APPLICATION NO.	FILING DATE	FIRST NAMED INVENTOR	ATTORNEY DOCKET NO.	CONFIRMATION NO.
10/696,587	10/30/2003	John Wirth JR.	3584-33	7205
23117	7590 09/29/2005		EXAMINER	
NIXON & VANDERHYE, PC			NGUYEN,	PHONG H
901 NORTH GLEBE ROAD, 11TH FLOOR ARLINGTON, VA 22203			ART UNIT	PAPER NUMBER
111121110101			3724

DETAILED ACTION

See Fig. 1.

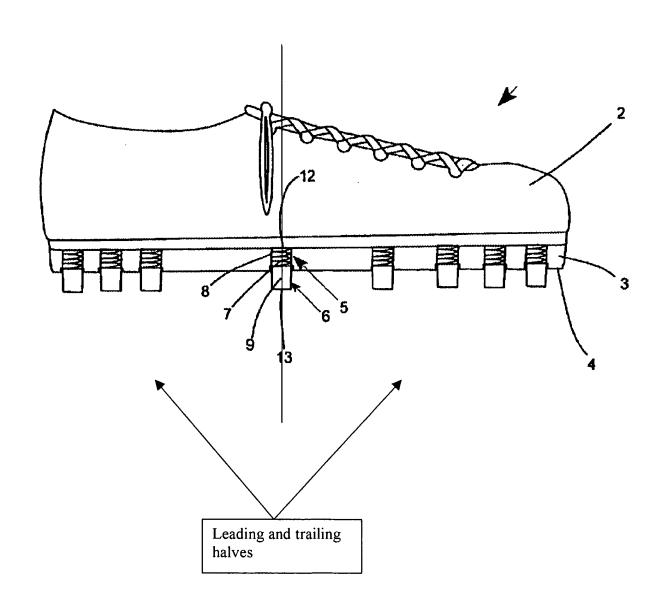
Regarding claims 1-4, Sizemore teaches a shoe capable of being used as a push block device for displacing a workpiece relative to woodworking equipment, comprising: a main body having a proximal end, a distal end, a longitudinal axis, and a first, generally flat working surface 4; a handle component 2 extending from the main body whereby when the first working surface is disposed in parallel facing relation to a top surface of a workpiece, the handle component is disposed predominantly vertically above the main body; and a heel component 6 extending from the main body so as to have a first, operative position, wherein the heel projects vertically below a first plane of the first working surface, and a second, stored position wherein the heel is disposed in or vertically above the first plane, the heel defining a second working surface disposed in a second plane defined at an angle with respect to the first working surface.

Regarding claim 11, the retention plate (the plate on the top of element 3) is best seen in Fig. 1.

Regarding claim 12, element 3 is considered a slip resistant pad since it is made of rubber. See Fig. 1 and col. 2, lines 47-55.

Regarding claim 15, see attached Fig. 1.

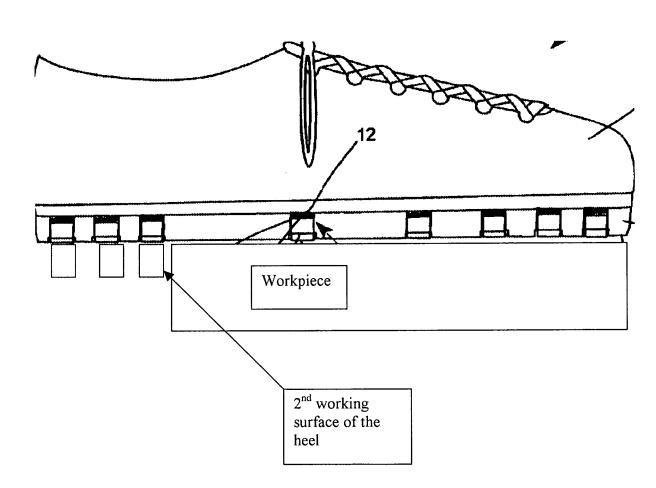
Although the Sizemore's shoe is not a push block, it is capable of being used to push a workpiece. Sizemore teaches a second working surface capable of engaging a trailing surface of a workpiece for advancing the workpiece. See below sketch.
